TSG-RAN Working Group 1(Radio) meeting #4
Yokohama, Japan, 19 – 20 April 1999

TSGR1#4(99)385

Agenda Item:	5.5
Source:	**editor**
Title:	Text proposal regarding S1.13 figures 1 and 2 channelisation code
Document for:	agreement

Figure 1   Spreading/modulation for uplink DPDCH/DPCCH for user services less than or equal to 1024kbps in the 5MHz band

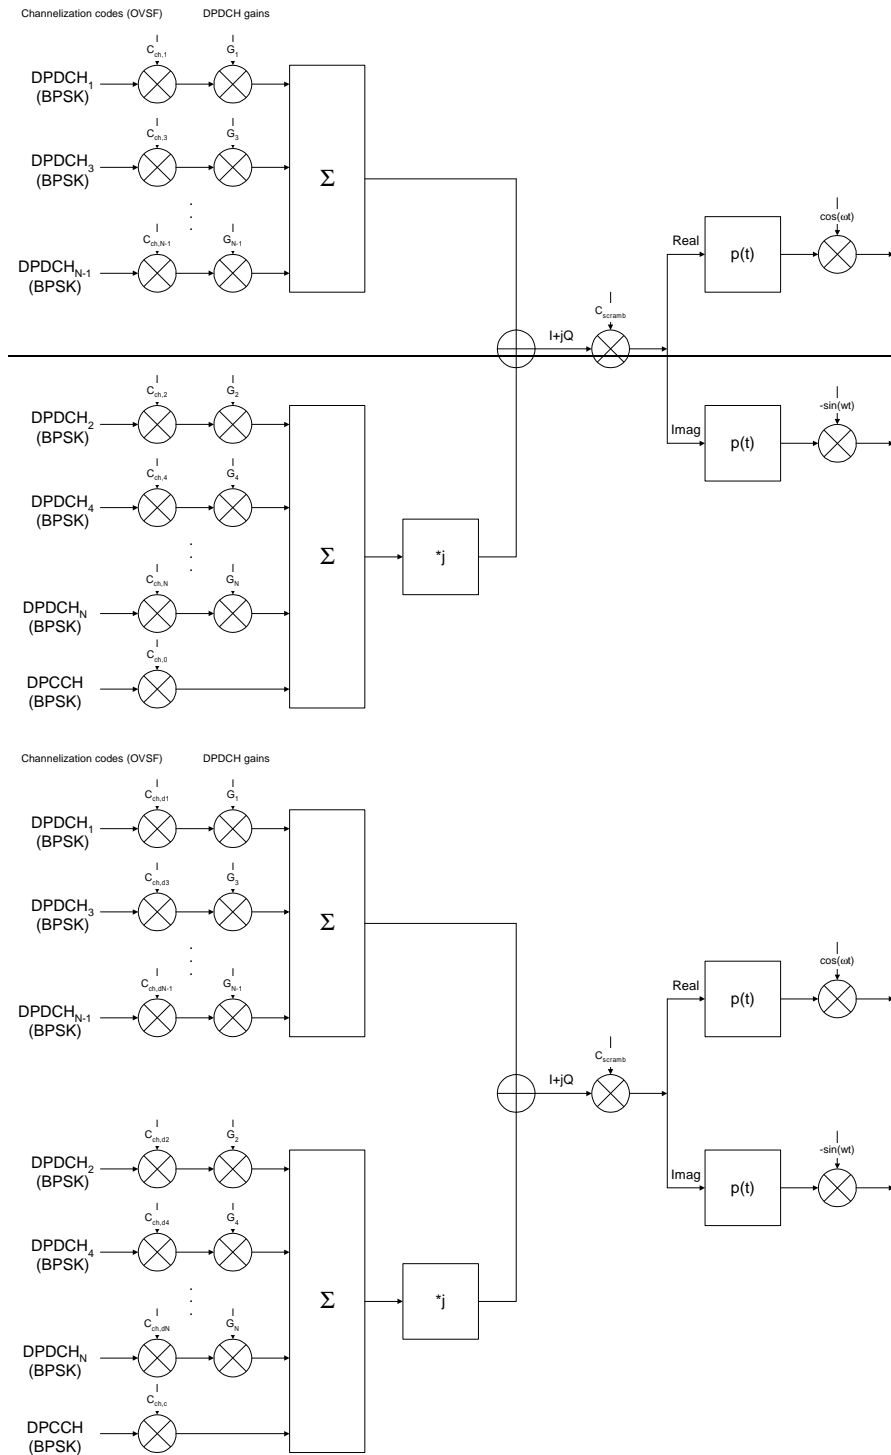
It has recently been discovered that figures 1 and 2 use the convention 0..N for indicating DPCCH and DPDCH codes and this has led to confusion amongst readers and this should be modified to increase clarity.

I propose that the DPCCH have code 'c' rather than '0' and the DPDCH code identifiers be 'd#' rather than '#' (a numeric).
